PIERCE MANUFACTURING INC.

# SERVICE BULLETIN

**TO:** Service Bulletin Distribution  
**FROM:** Pierce Customer Service  
**DATE:** 1-29-08 UPDATED 1/6/2016  
**RE:** SERVICE TOPIC# 256B Modine Radiator Service

**Modine radiator part number #1225672 installed in the Dash, Lance and Enforcer Chassis. Pages 1 and 2.**

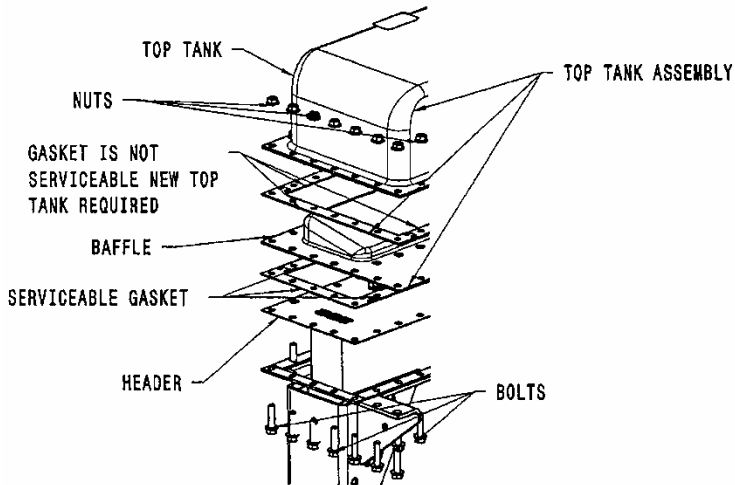
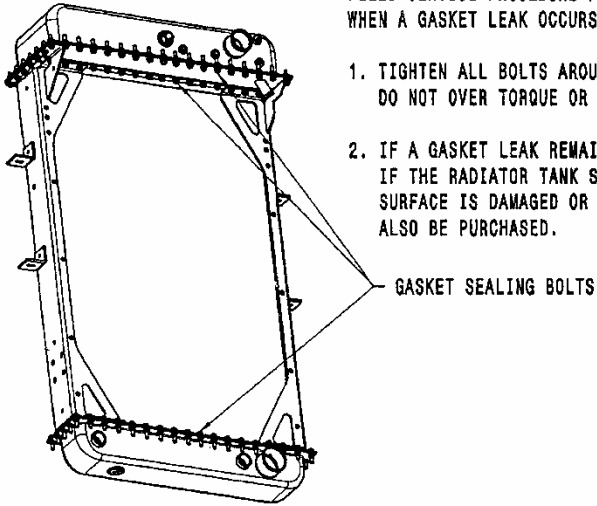
- Pressure test the radiator to determine the location of the leak. Do not exceed the pressure rating identified on the radiator cap
- If the sight glass is found to be leaking, remove it and disassemble the three-piece assembly. Check the condition of the o-ring seal on the glass. If the o-ring is flattened out, replace it with a locally purchased viton o-ring or order a new sight glass assembly from Pierce. (Part # 1471647)
- If no leak can be found, check the radiator cap to make sure it relieves at the proper pressure as listed on the cap. If it relieves too early, antifreeze will be lost through the over flow tube. If the cap does not relieve properly, excess pressure will build and may cause leaks. Replace cap if needed.
- If a leak is found at the upper or lower tank, follow the Modine repair procedure included with this bulletin.

Image A: Without C-Shaped Bolting Bars

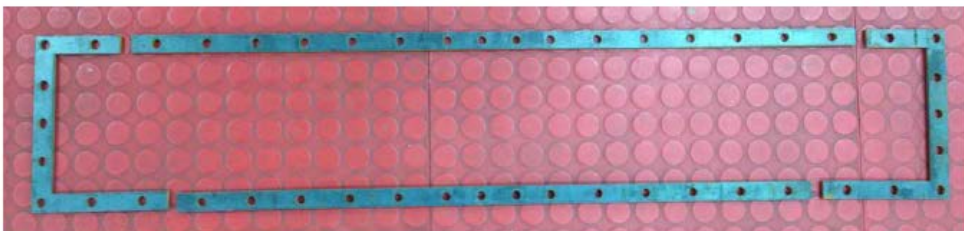
1. When the radiator is determined to be leaking, and the radiator is not updated with the latest C-shape bolting bars (Image B), install service kit 2896576 (Kit, Gasket Service, Radiator) with C-shaped bolting bars and one piece gasket (Image B), torque the new bolts to 300 in-lbs.
2. If step one does not stop the leakage, remove and replace the radiator assembly with service part number 2896564 (Radiator,MOD,CU-BR,14-PLT CLR). This radiator includes the C-shaped bolting bars and one piece gasket installed directly from the supplier.
